RESIDENTIAL ENGINEERING SERVICES, LLC.
SHOP DRAWINGS/SUBMITTAL REVIEW

JOB No.	2532764
DESCRIPTION	Summit - Woodside Ridge #5
JOB ADDRESS	106 NW Grady Ct.
CITY	Lee's Summit, MO
DESIGNER	Scott Cleverger
DATE	11/14/2020

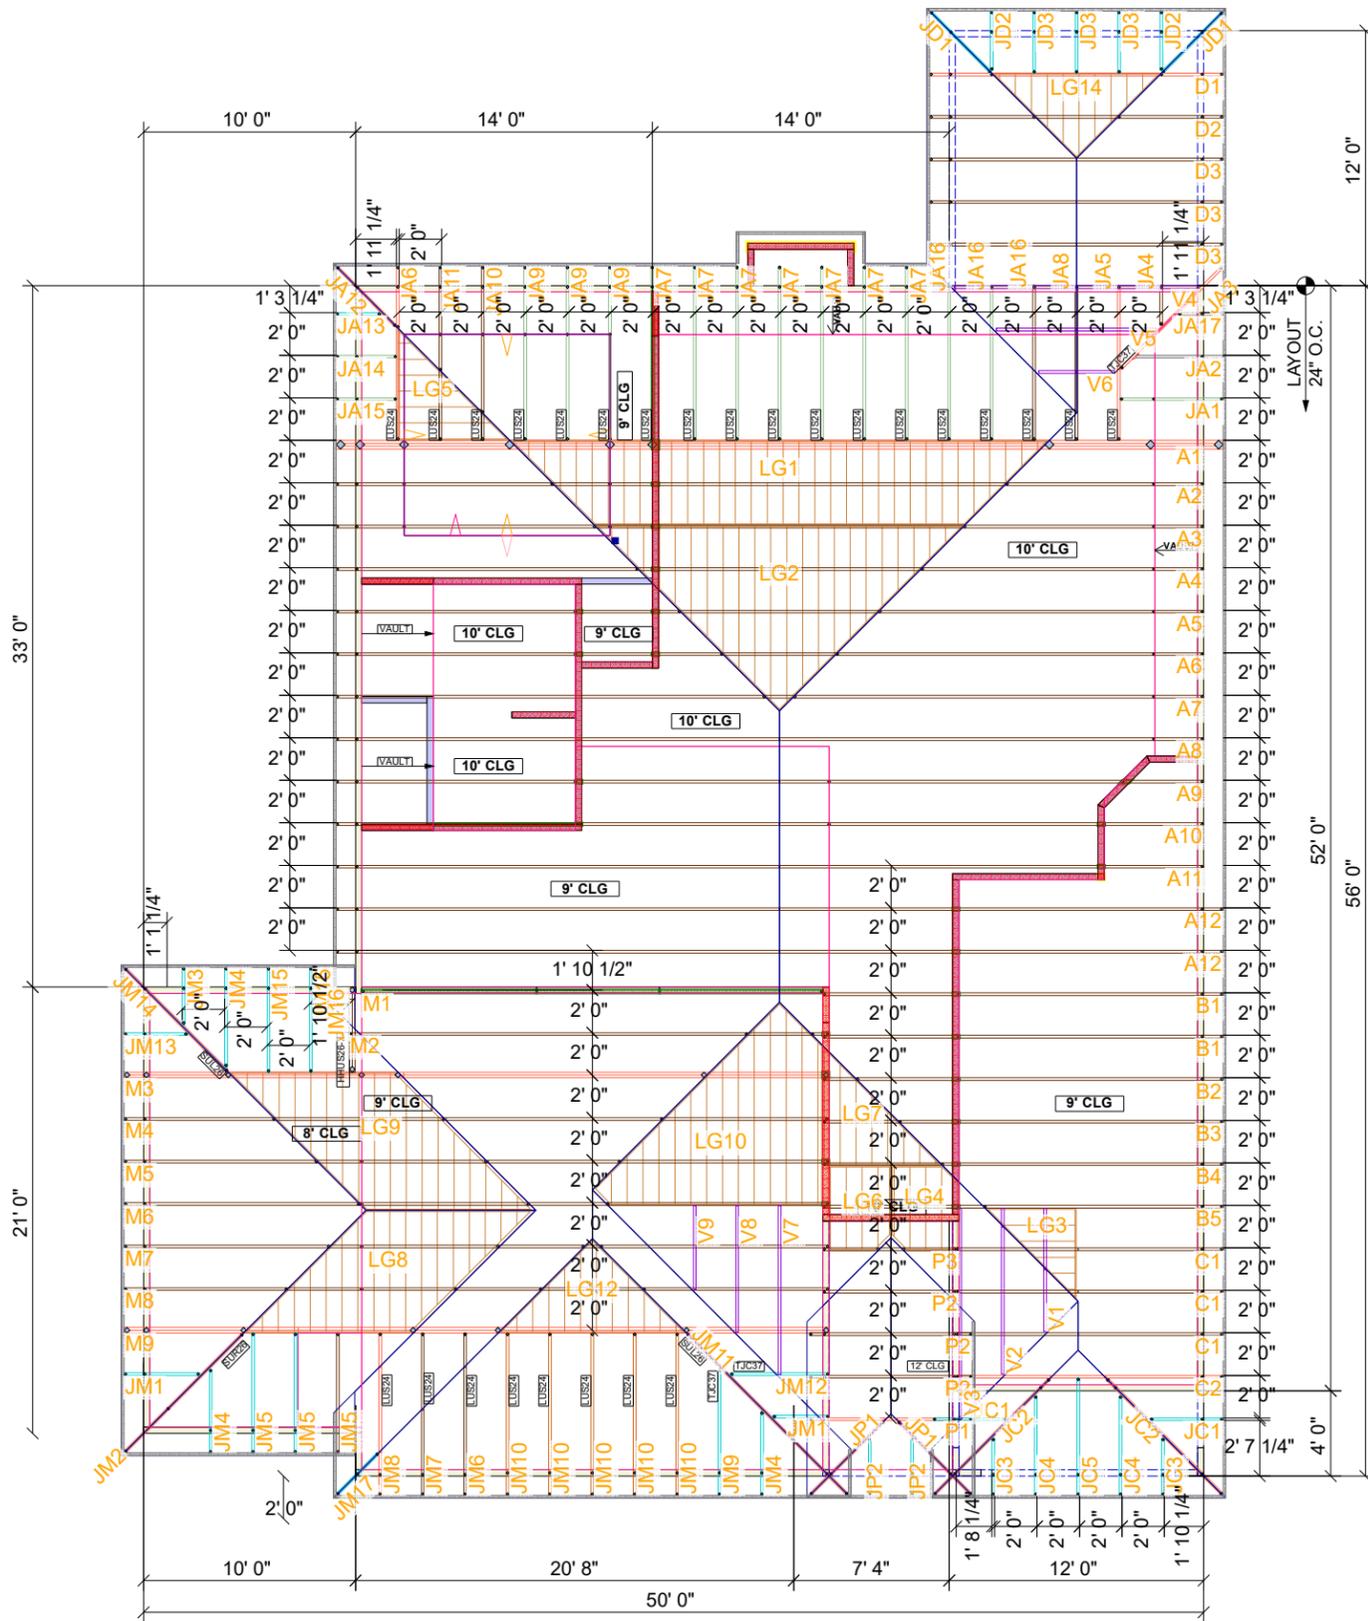
STATUS:
APPROVED
